PLANNING DEPARTMENT

November 10, 1999

OHANA DWELLING PERMIT NO. 3849 (OHD 99-008)
Applicant: ROBERTA KVENILD
Titleholder: ROBERTA KVENILD
Additional Single Family Dwelling
Tax Map Key: (3) 2-8-014:009

REVISED SITE PLAN

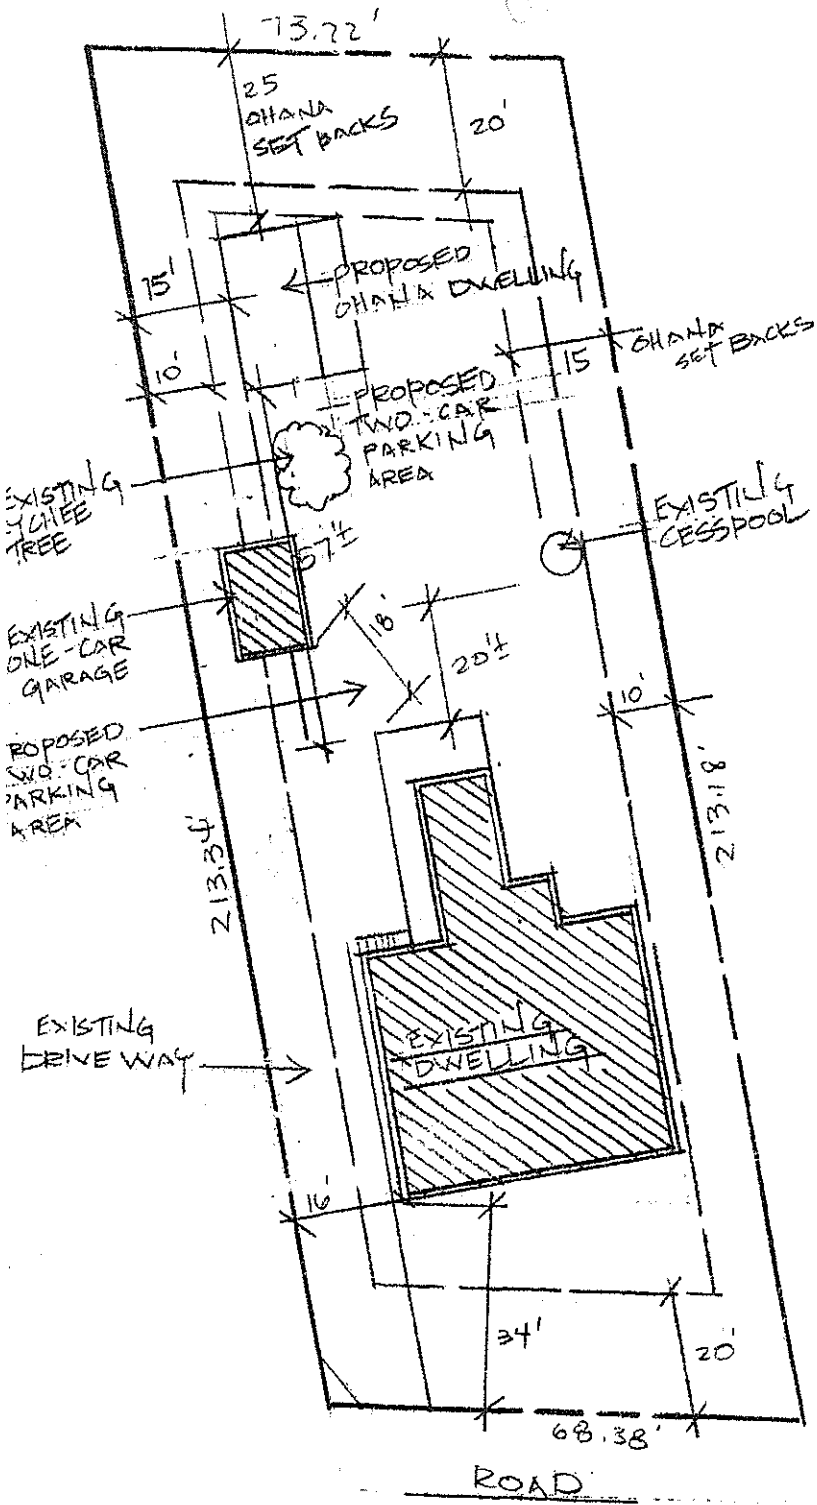
"All new driveway construction will require a driveway permit from the Department of Public Works."
2. The Department of Water Supply (DWS) memorandum dated October 6, 1999, states in part:

For your information, an existing 5/8-inch meter services the property and is adequate for only one dwelling at 600 gallons per day. This application is proposing an additional detailed dwelling, so the installation of a separate 5/8-inch meter by the applicant is required in accordance with Department regulations.

1. Installation, by the Department of Water Supply, of a second 1-inch service lateral to service a 5/8-inch meter, which shall be restricted to a maximum daily flow of 600 gallons as the existing service is.
2. Remittance of the following charges, which are subject to change to change, to our Customer Service Section:
 - a. Facilities Charge (One 2nd service at \$3,375.00) \$3,375.00
 - b. Service Lateral Installation Charge
(Install one meter on a County road) 1,200.00

"The existing cesspool may service a total of 1,000 gallons per day of wastewater. A total of five bedrooms are allowed in the two dwelling units. A second cesspool is not allowed because of the lack of land area."

"Fire apparatus access roads shall be in accordance with UFC Section 10.207..."

"Fire extinguisher shall be in accordance with UFC Standard 10-1."

3. Requirements for Height, Site Area (Lot size), Yard (Setback) and Off-Street Parking (Parking spaces):
 - a. Height limit: The height limit for the proposed ohana dwelling unit shall be twenty-five (25'-0") feet.

- c. Minimum Yards (Setbacks): The proposed ohana dwelling unit is required to comply with the minimum building yards of the Zoning Code, RATIFIED: APRIL 6, 1999. The minimum building yards are as follows: front/rear yards - minimum twenty-five (25'-0") feet and side yards - minimum fifteen (15'-0") feet.

- d. Off-Street Parking: An Ohana Dwelling unit shall be provided with a minimum of two (2) off-street parking spaces which comply with the requirements of Section 25-4-53, Chapter 25, RATIFIED: APRIL 6, 1999. All existing and additional parking spaces shall be arranged so as to be individually accessible.
